TECHNICAL BULLETIN DOC00039

How to Identify the 3230 PC Board

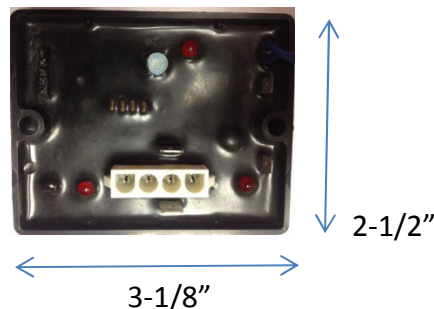
We are aware of one model of PC Board with the potential of over-heating. This PC Board (Model 3230) was supplied to and installed on certain A&M Systems Door Headers manufactured from August 1, 2009 through March 31, 2010. Additionally, PC Boards that were field replaced during this time period could be affected and will need to be inspected. While these reports are few, the over-heating situation could cause the PC Board to burn in extreme cases. As a result we are sending this Technical Service Bulletin to help you identify and replace this PC Board.

Only the Model 3230 PC Board has shown the potential to over-heat. Please be aware of the importance of this Technical Bulletin. Your prompt attention to this is highly recommended and should be completed no later than December 31, 2013.

1. Remove PC board from Header – PC Board is attached to Header plate with double face tape.
 - a. Unplug the four-pin connector feeding the board.
 - b. Unplug the blue wires from the open limit switch.
 - c. Remove the board by twisting and pulling the board off the header plate.
2. Remove the Information Label from the 3230 Model PC Board showing the 3230 Model number on the label.
3. **Record the following from the removed PC Board:**
 - a. The scribed information from the outside edge of the board _____.
 - b. Header Model _____.
 - c. Header S/N _____.
 - d. Vehicle VIN _____.
4. Cut the two blue wires near the base and using the pre-addressed, postage paid enclosed envelope, send the label, the clipped wire harness and this form to:

5. Replace the existing fuse powering the PC Board with a 20 amp fuse.
